World Forum for Harmonization of Vehicle Regulations

Working Party on Brakes and Running Gear

Motorcycle braking – Regulation No. 78

Proposal for amendments to Regulations No. 78 (Uniform provisions concerning the approval of vehicles of categories L₁, L₂, L₃, L₄ and L₅ with regard to braking)

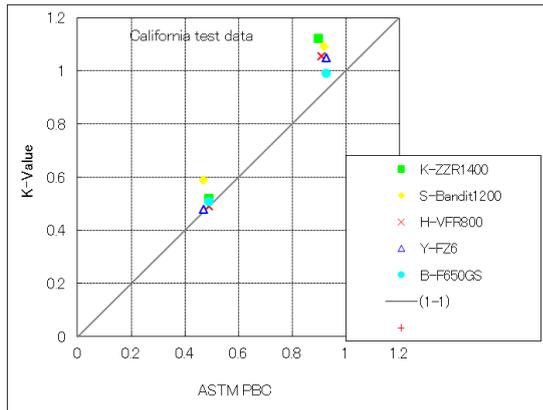
- (c) During GTR3 discussions, a correlation test between K-method and ASTM method had been carried out in California. The data from the test are shown in the graph below.

PBC values by K-method were for same course, and the following were recognized.

- PBC values were different by measuring motorcycle (tyre).
- Such level of difference should be permitted.

It was recognized that even for the same course PBC values were different for each motorcycle. It was noted that it is beneficial to measure the PBC values of the course using the same motorcycle to maintain the course PBC value condition.

The IMMA proposal includes a condition saying that the choice of a motorcycle is subject to the confirmation of the correlation level of the motorcycle for K-method to ASTM method. IMMA believes that a motorcycle with correlation level similar to the one tested in California can be a representative vehicle to be used for measuring PBC values of the course.

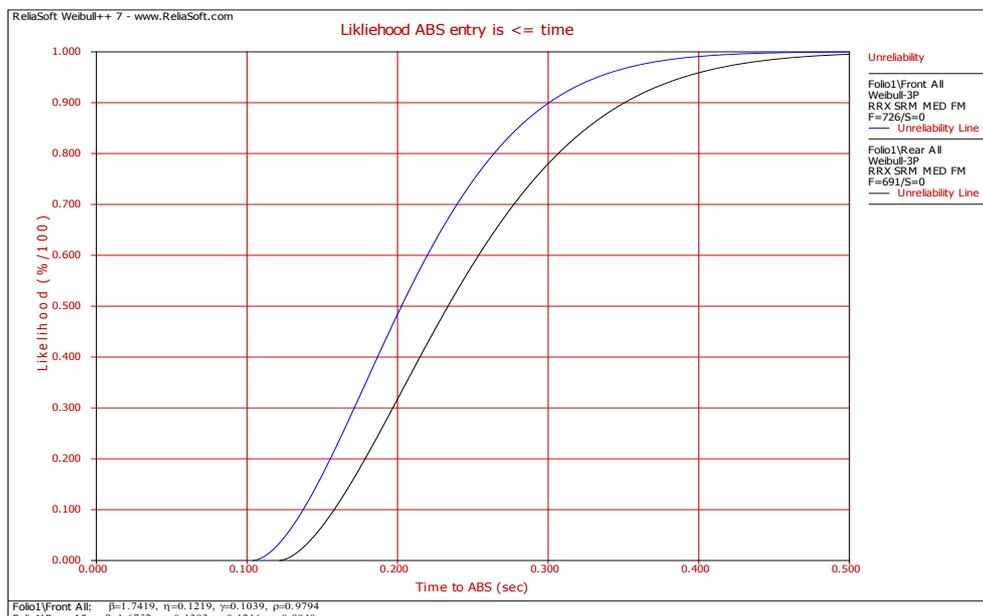
It has been noticed in testing that the brake application rate specified in section 4.9.5.1 can result in a large number of test failures. It can be seen in the chart below that the 0.2 second lower limit shows a failure rate is between 30 per cent and 50 per cent of the time.

By reducing the lower limit to 0.1 seconds, the test failure rate reduces to practically zero. Allowing the reduction tends to make the regulation more stringent by including a greater number of brake force application rates and eliminates restrictive test requirements.
